HUNTS POINT INTERSTATE ACCESS IMPROVEMENT PROJECT – CONTRACT 3

PIN X731.65, Contract D900055

Addendum #8

July 22, 2022

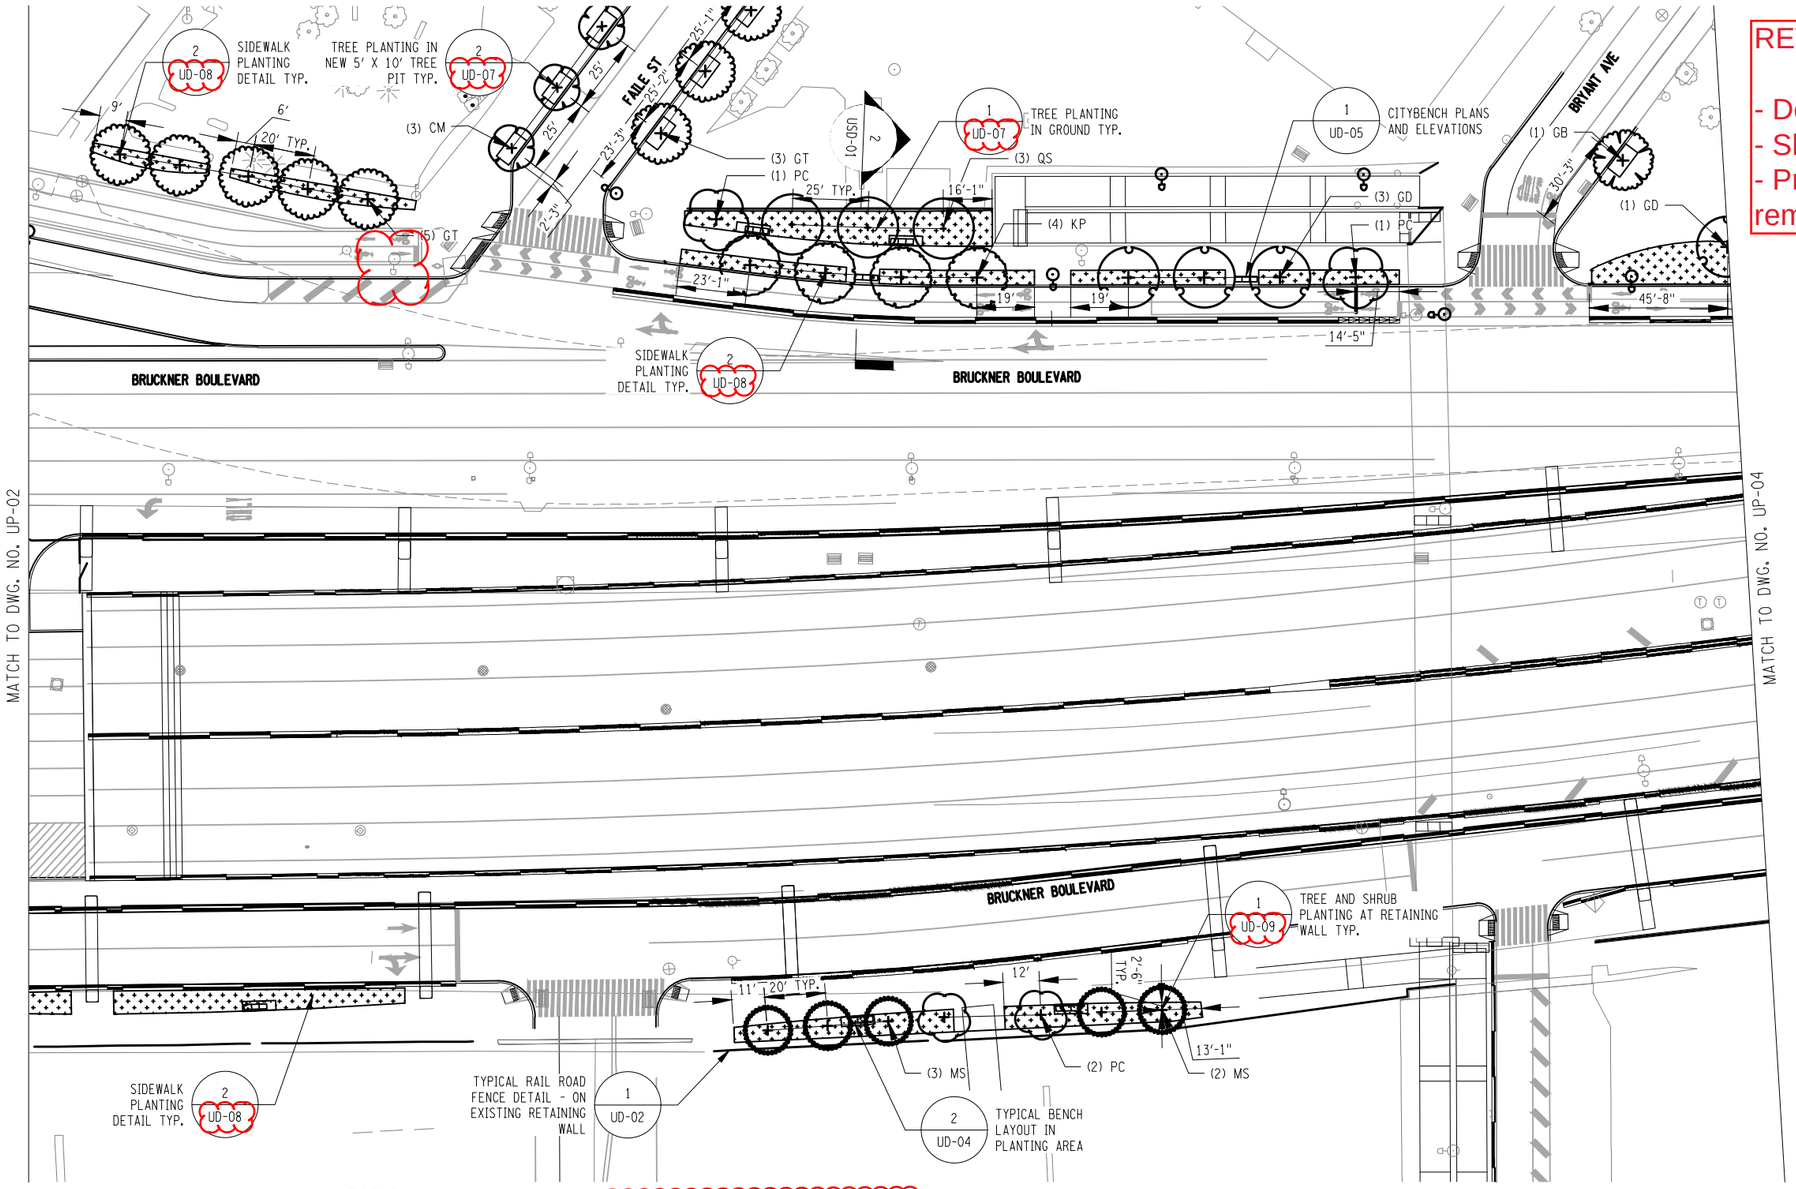
- Detail callouts corrected.
- Sheet legend updated.
- Proposed light pole removed.

MODIFICATIONS AND STRENGTHENING TO EXISTING STEEL STRINGERS

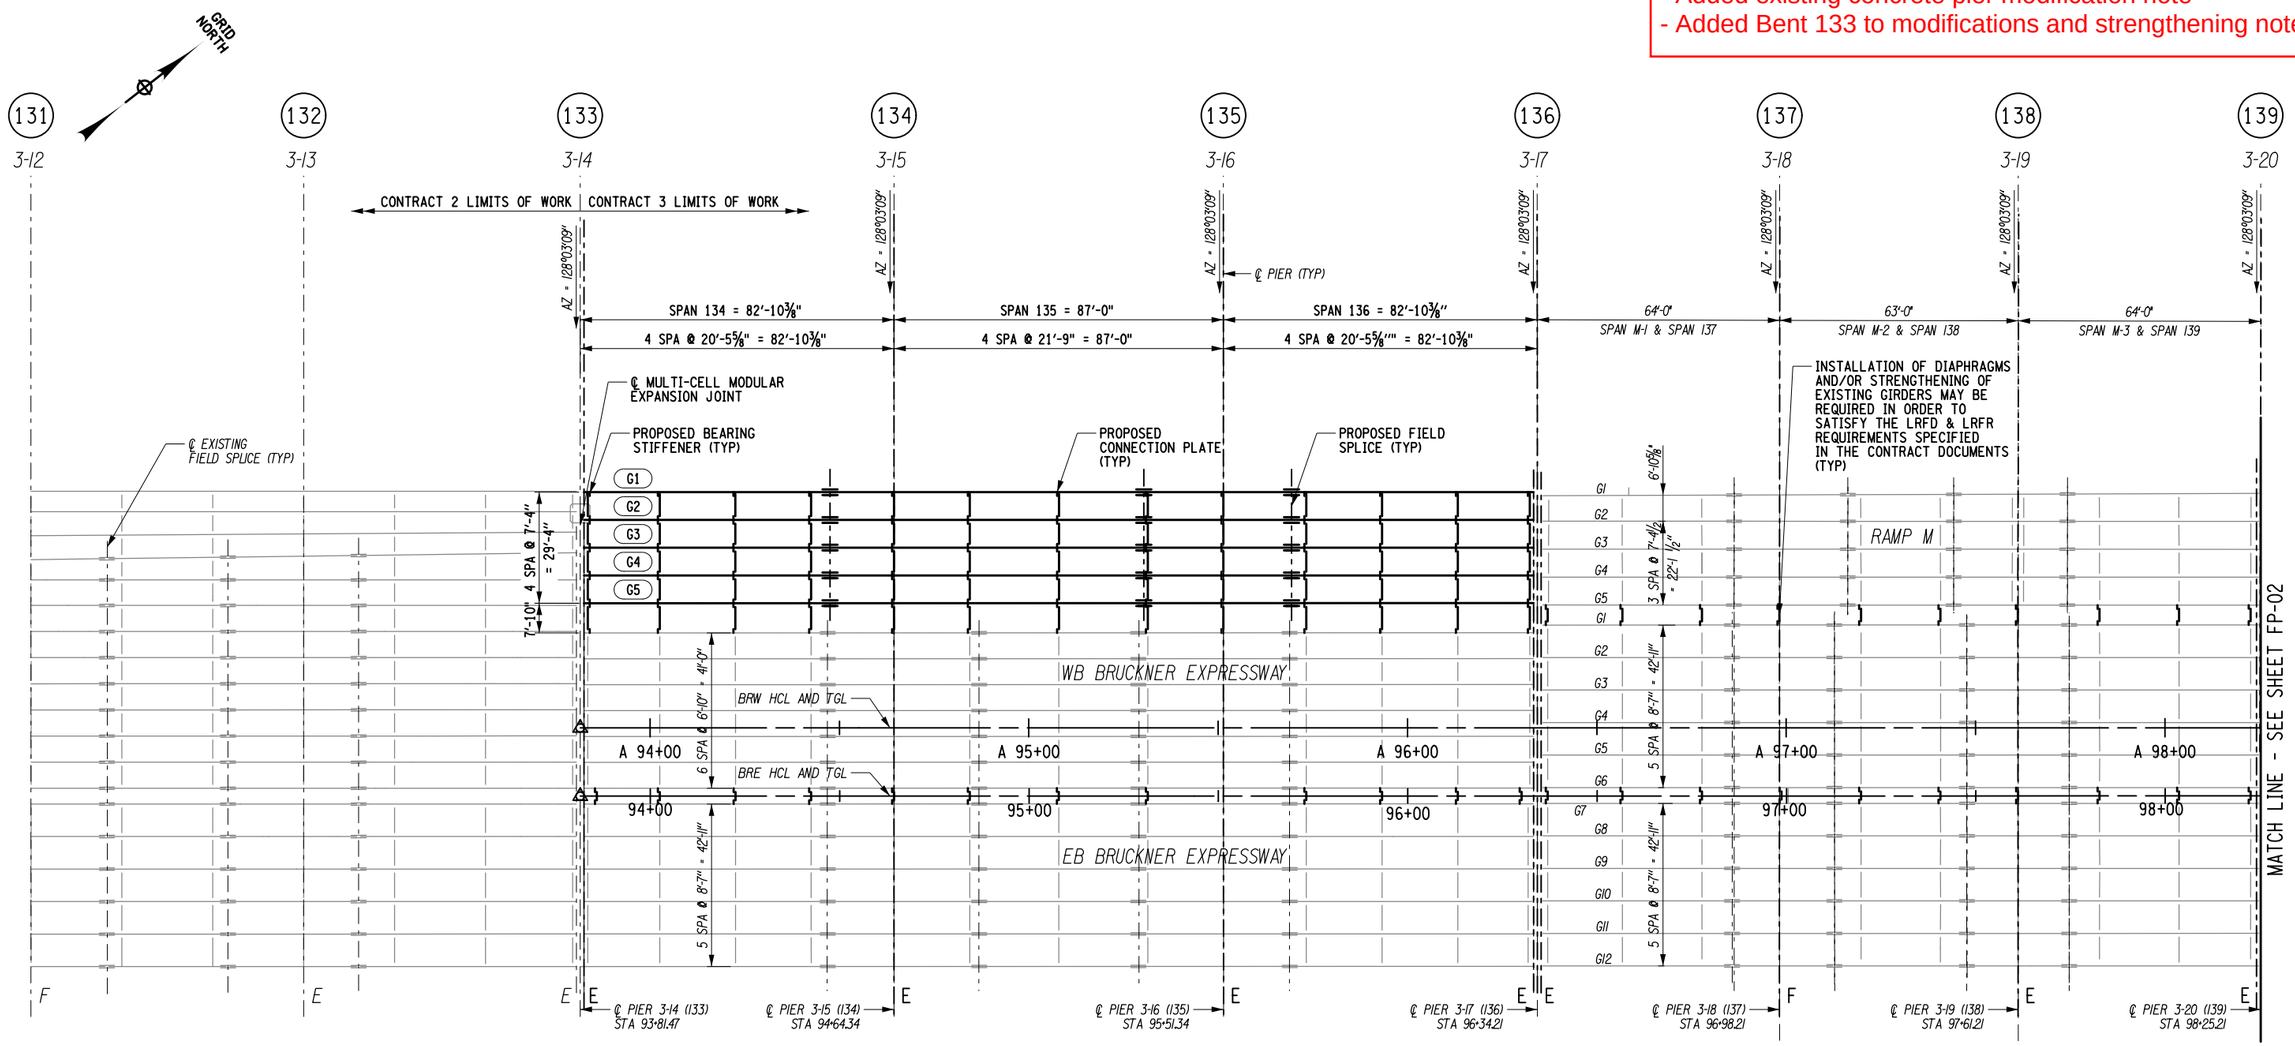
List of Revisions for Addendum #8
- Added existing concrete pier modification note
- Added Bent 133 to modifications and strengthening note

PROPOSED FRAMING PLAN

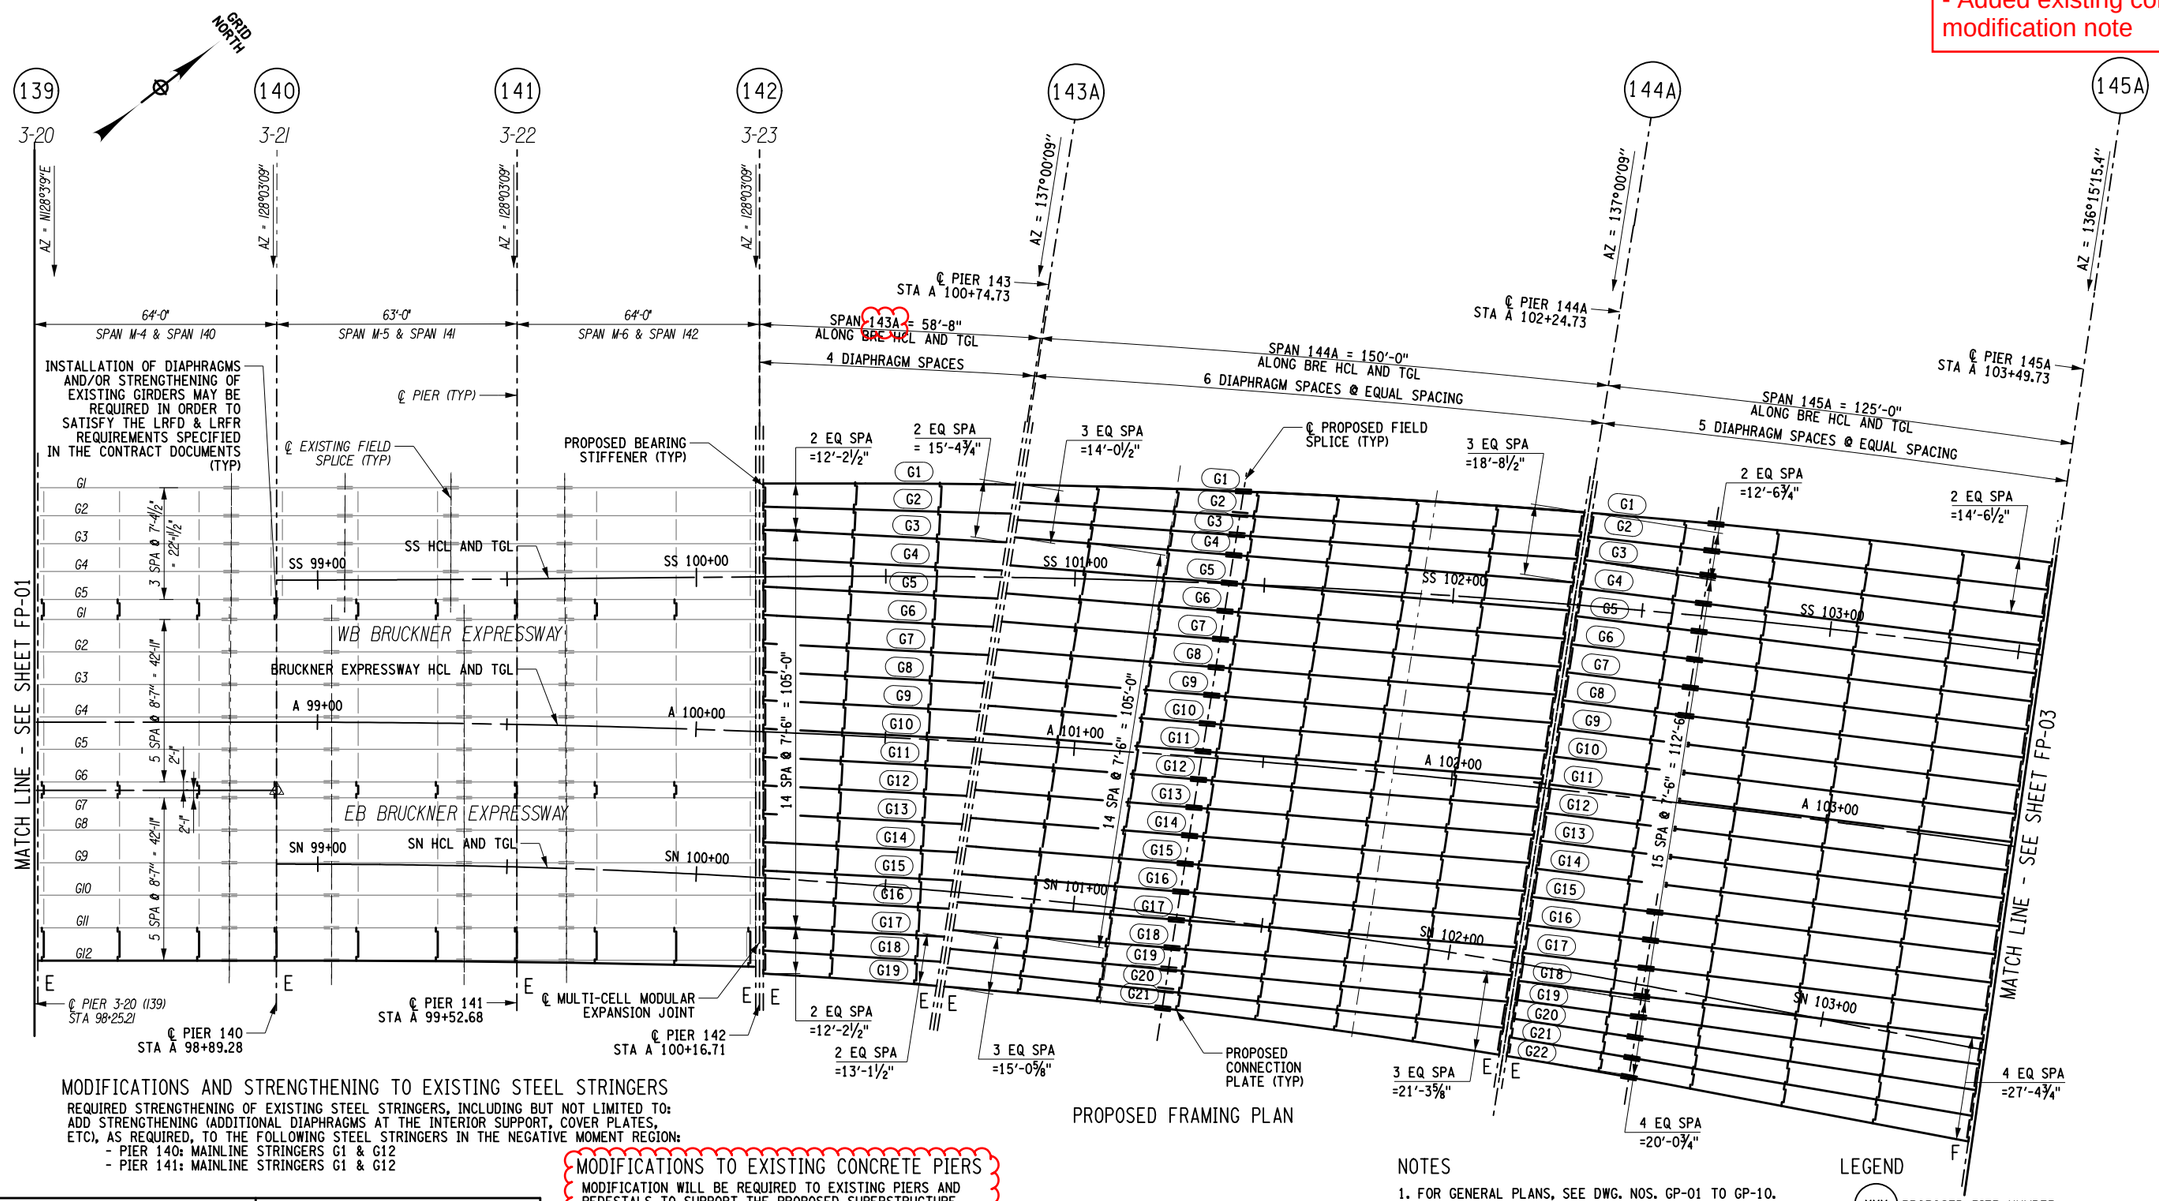
List of Revisions for Addendum #8
- Added existing concrete pier modification note

EXISTING FRAMING PLAN

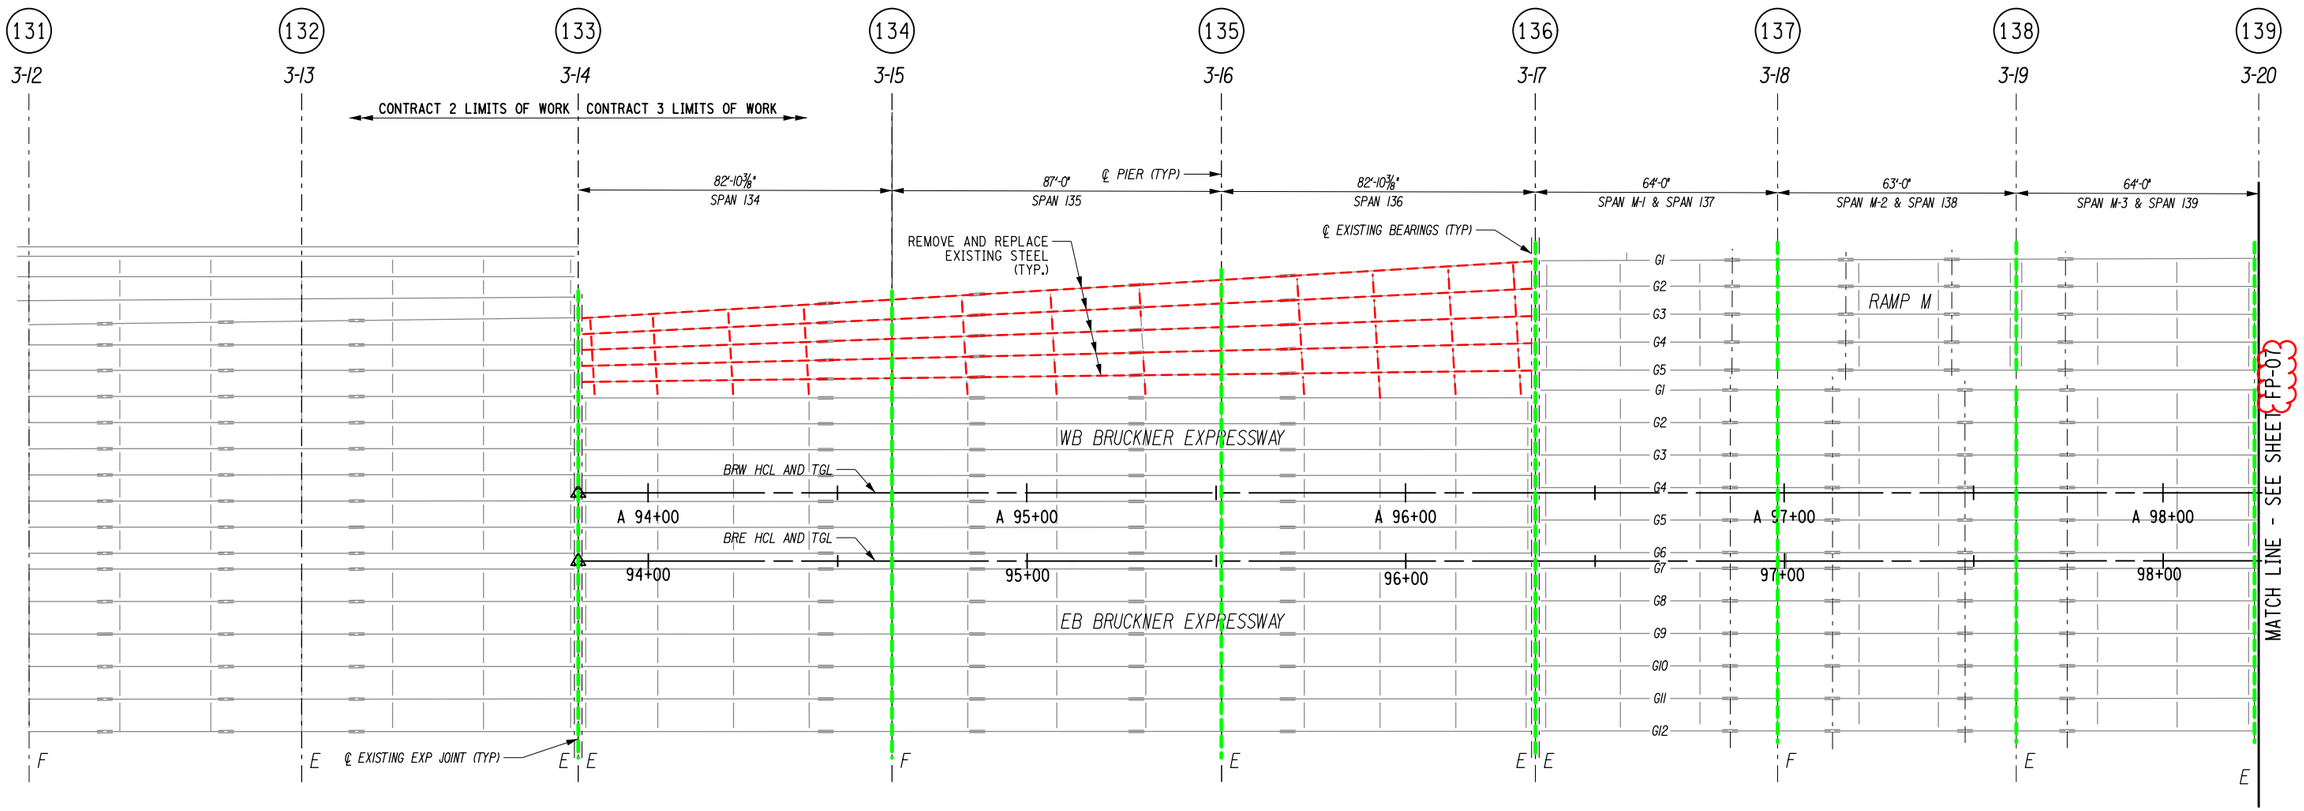
Revisions for Addendum 8:
- Revised match line text
